Safety report for paragliders PHI with R07 risers (01/11/2024)

To be on the safe side, the manufacturer issues the following safety statement: The carrying straps R07 for the samples - ALLEGRO X-alps (later ALLEGRO light)

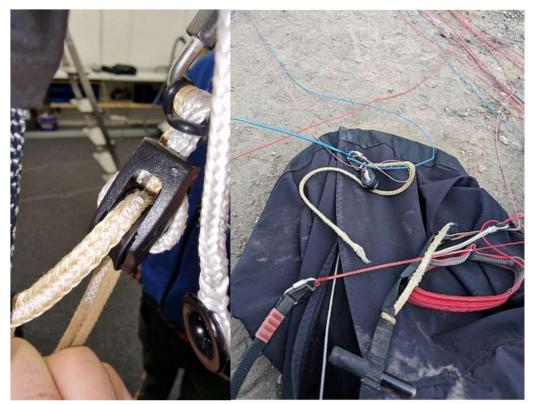
Technora leash from Edelrid. Presumably the friction on a sharp edge of the pulley (Ronstan) caused damage to the line and weakening it to the point of breaking. When it comes to ranking, there is a series variation among the roles used.

From the visual impression of the risers, the paraglider in question was very heavily used. There are clear signs of abrasion on the leash.

MAESTRO 2, as well as all other PHI samples that are equipped with the optionally available R07 risers (Figure 3), must be subjected to a visual inspection. The check can be carried out by the owner himself and must be carried out before the next flight. If damage or wear is discovered, the owners are requested to stop flying the affected paraglider and to contact PHI or their PHI dealer about replacing the affected line and, if necessary, the pulley.
